Board identification

This errata sheet applies to some samples of the STMicroelectronics X-NUCLEO-IDW01M1, see the below information for details.

Figure 1: Board identification (R21)

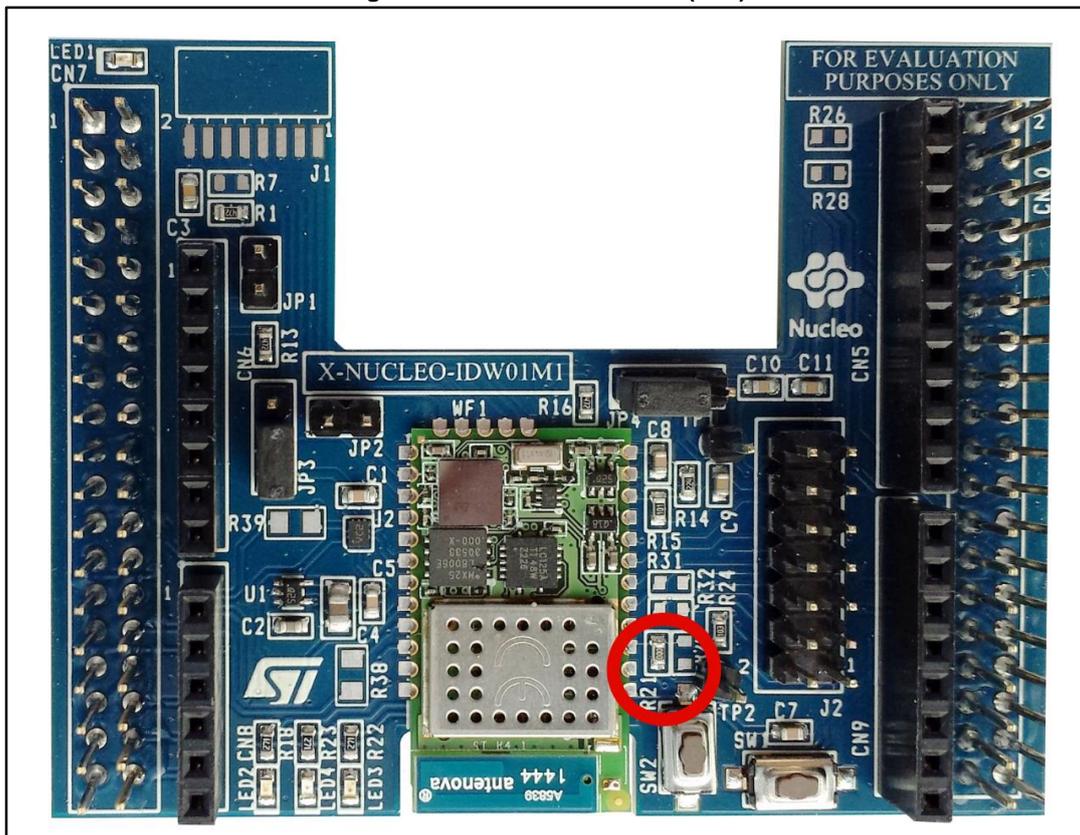
These boards mount R21 (see Figure 1) which may interfere with JTAG programming of STM32 on STM32Nucleo board.

Disassemble R21.
